ATTACHMENT 5

Letter from M. E. Warner (NMC)

License Amendment Request 187

Revised Pages for Updated Safety Analysis Report
(USAR)

Figure 14.1.2-1

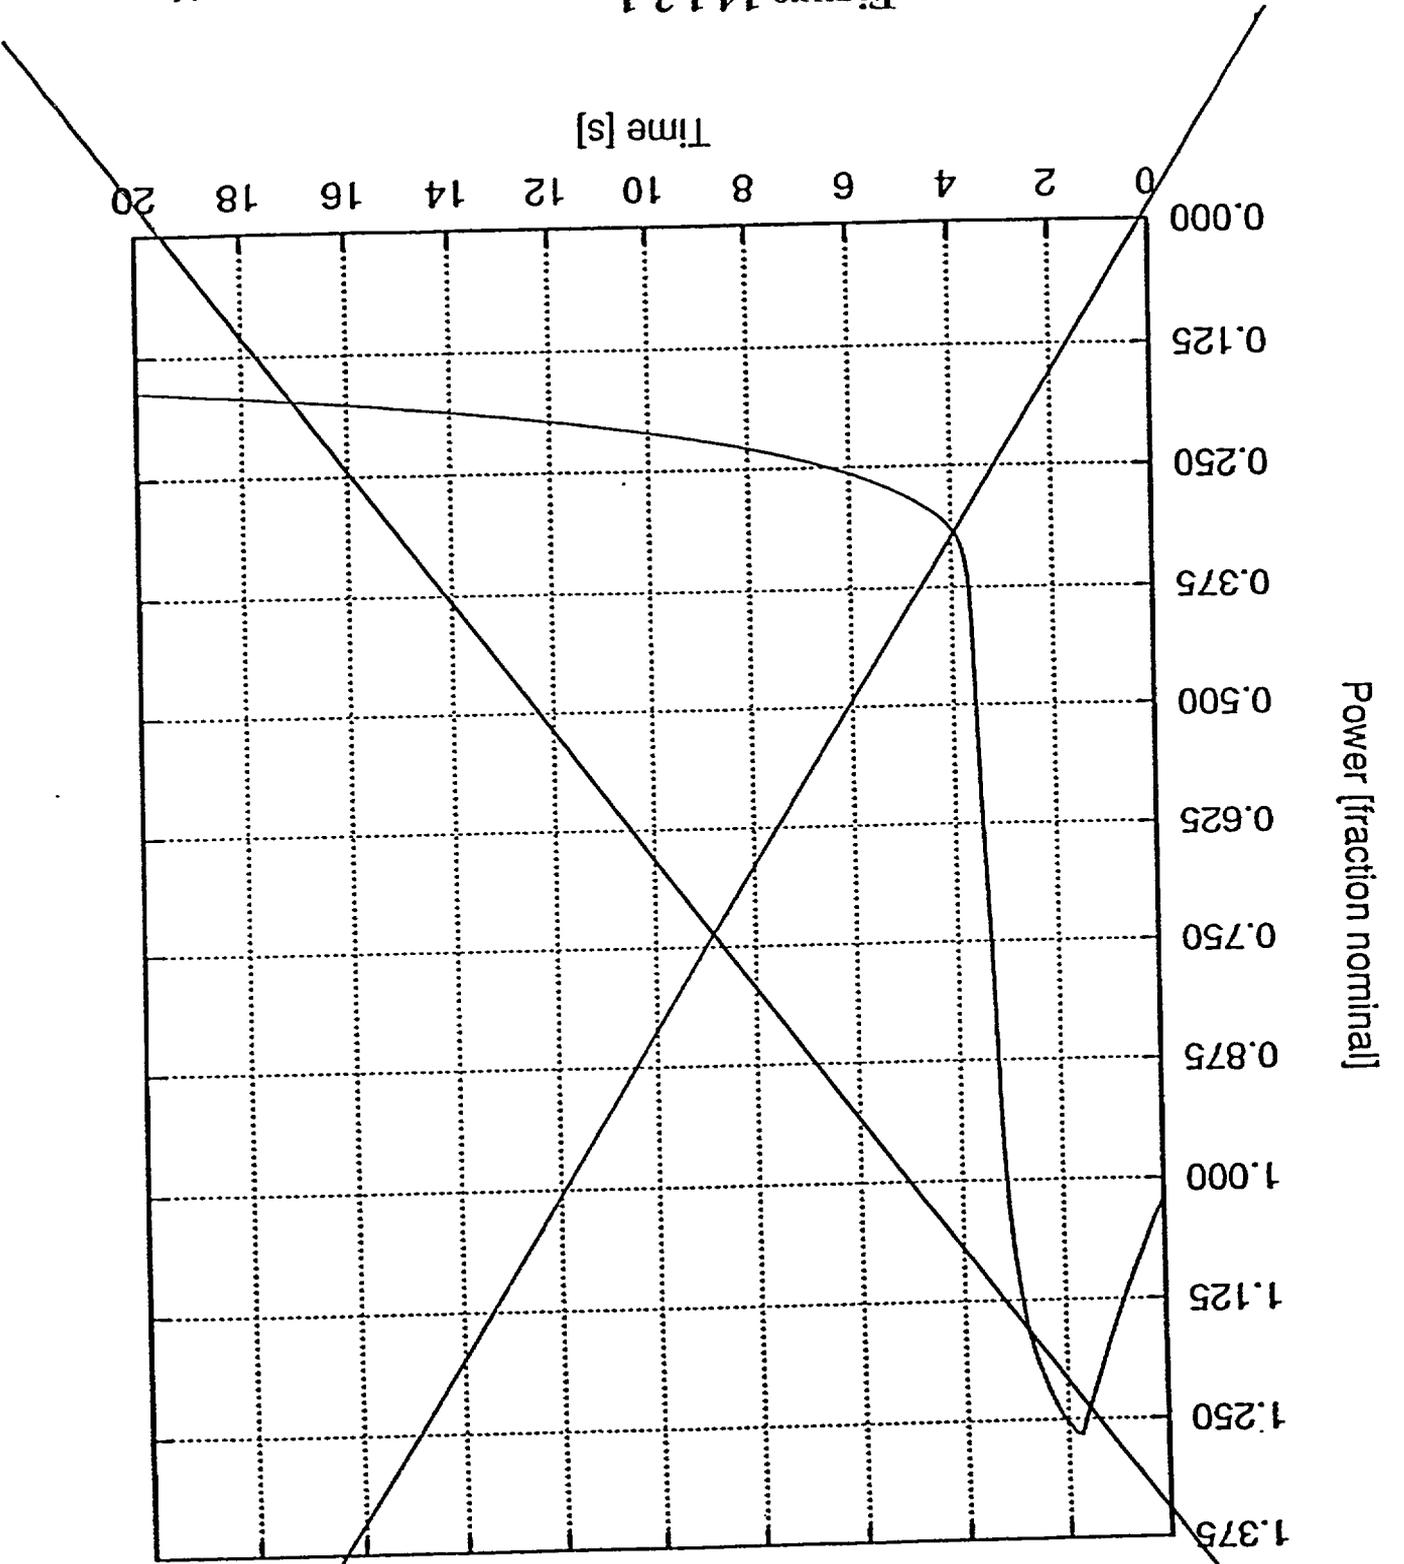
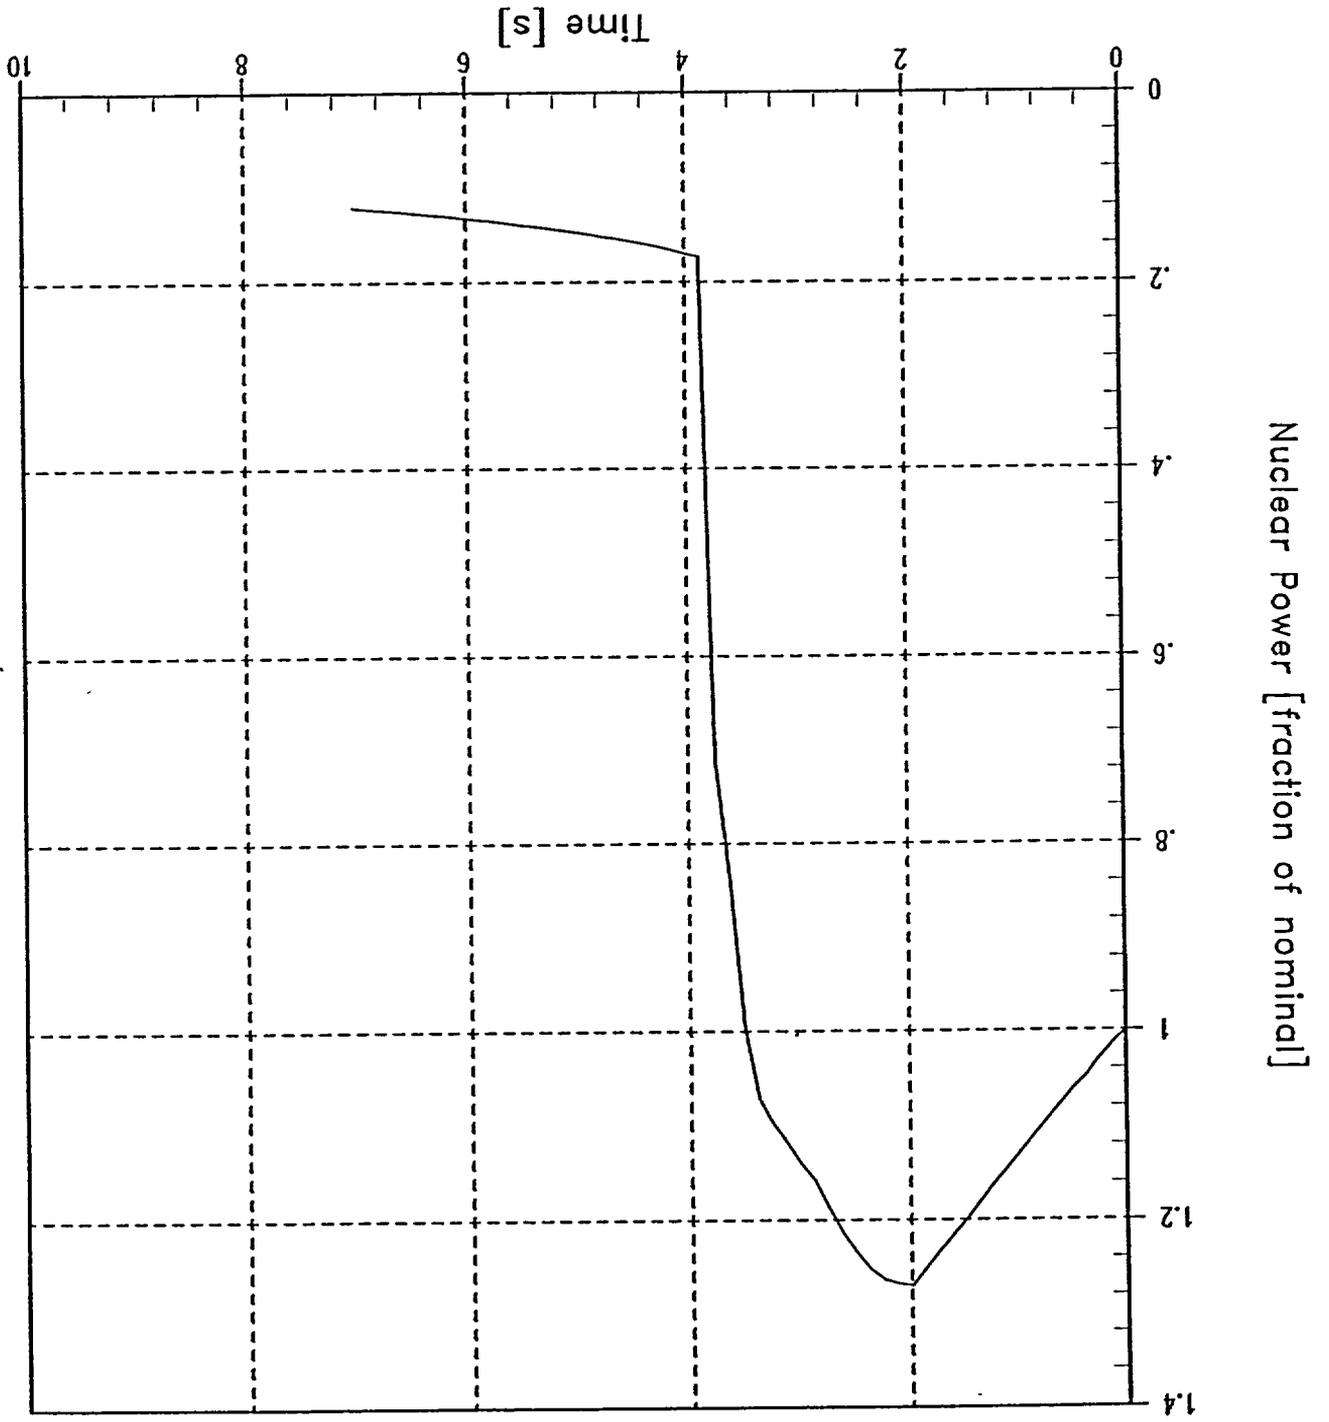
REPLACE WITH FIGURE THAT FOLLOWS

Figure 14.1.2-2

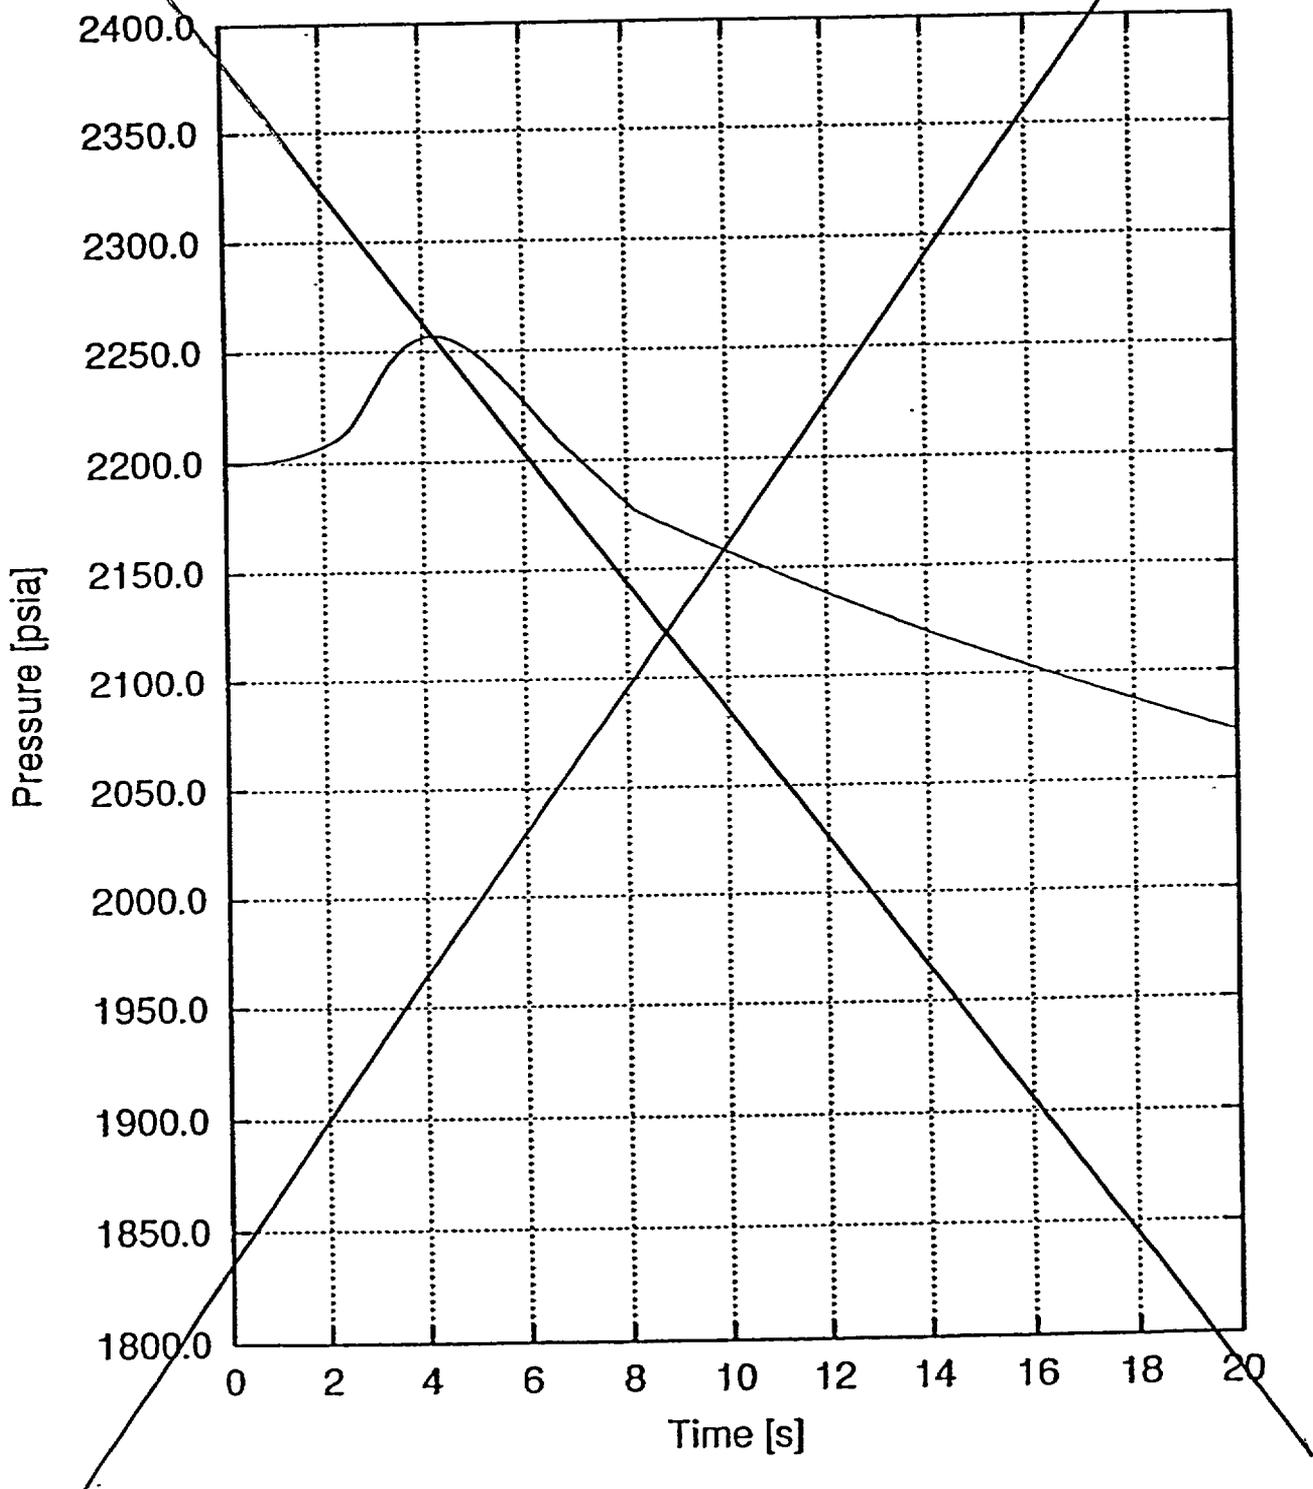
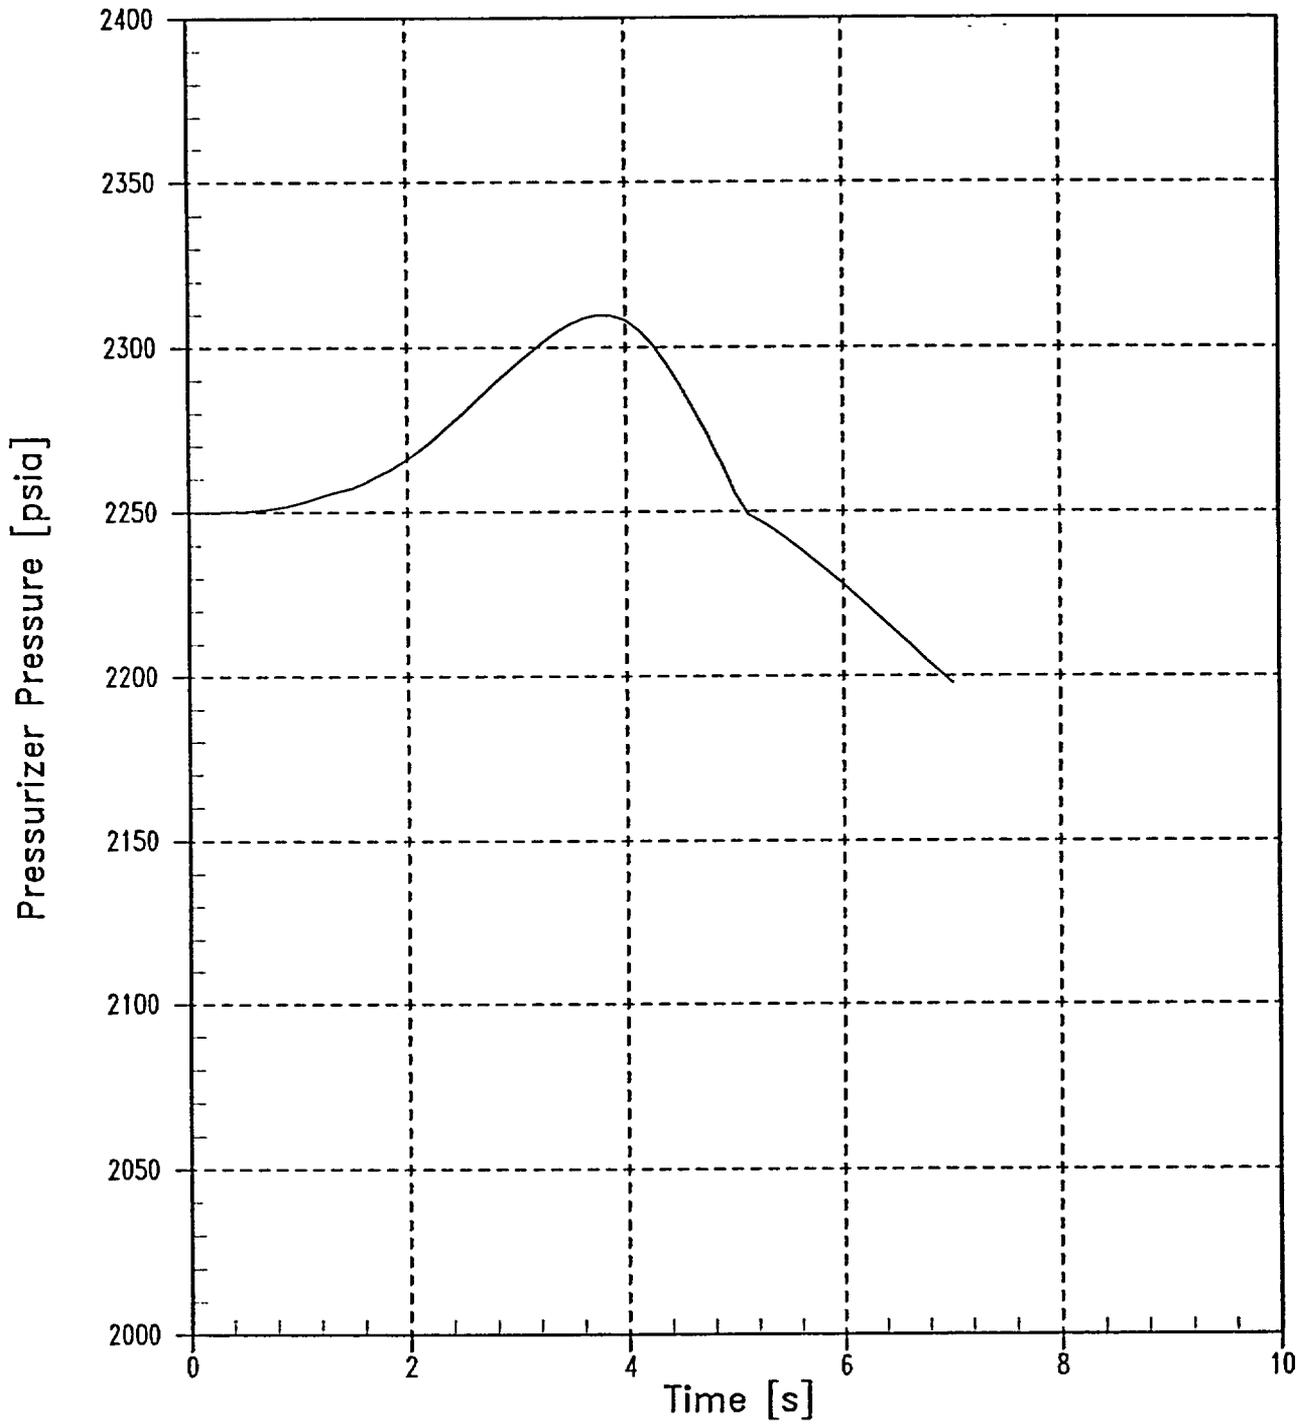
REPLACE WITH THE FIGURE THAT FOLLOWS
